231 Goldhurst Terrace, NW6 3EP

Basement Impact Assessment Audit

London Borough of Camden

Project Number: 12066-33 Revision: F1

Client: Francis Bennett Project: 231 Goldhurst Terrace Title : Structural Sections 1-1 & 2-2	Dwg Nos Rev SD-11 drawn Ch'k	Oct 14	Croft Structural Engineers Clockshop Mews, r/o 60 Saxon Rd, London, SE25 5EH. 020 8684 4744 www.croftse.co.uk	
--	------------------------------------	--------	--	--

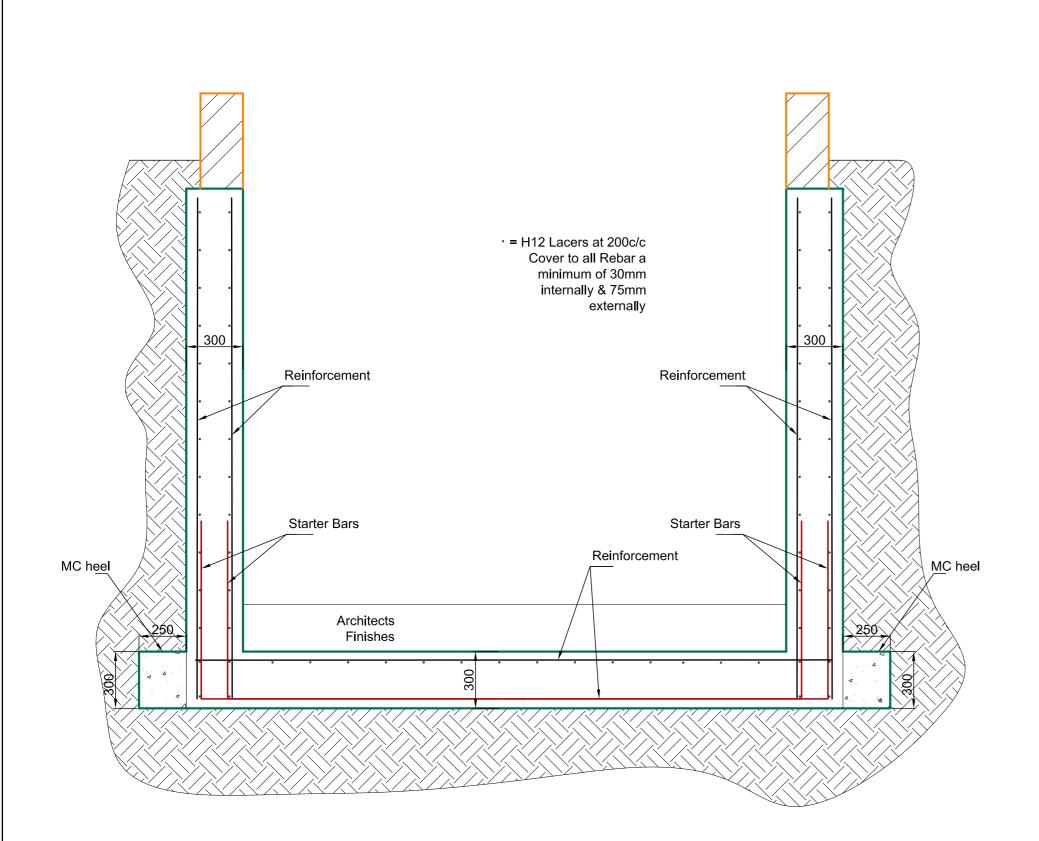
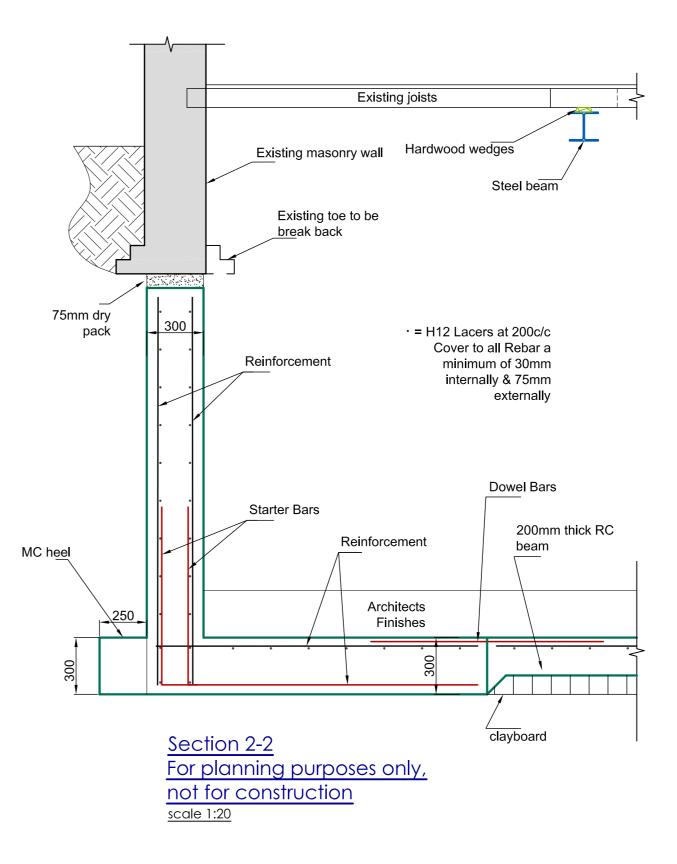
- 5.10. Earlier audits queried whether heave pressures on the proposed ground bearing slab had been considered and a slab uplift calculation was presented by CSE which showed a requirement for heave protection below the slab. Drawing 141002 SL-10 Revision 3 in Revision 5 of the BSMS shows suspended slab with heave protection placed beneath, although it should be noted that

the text still refers to a ground bearing slab. Due to this discrepancy, it is recommended that the design of the slab is confirmed in a Basement Construction Plan.
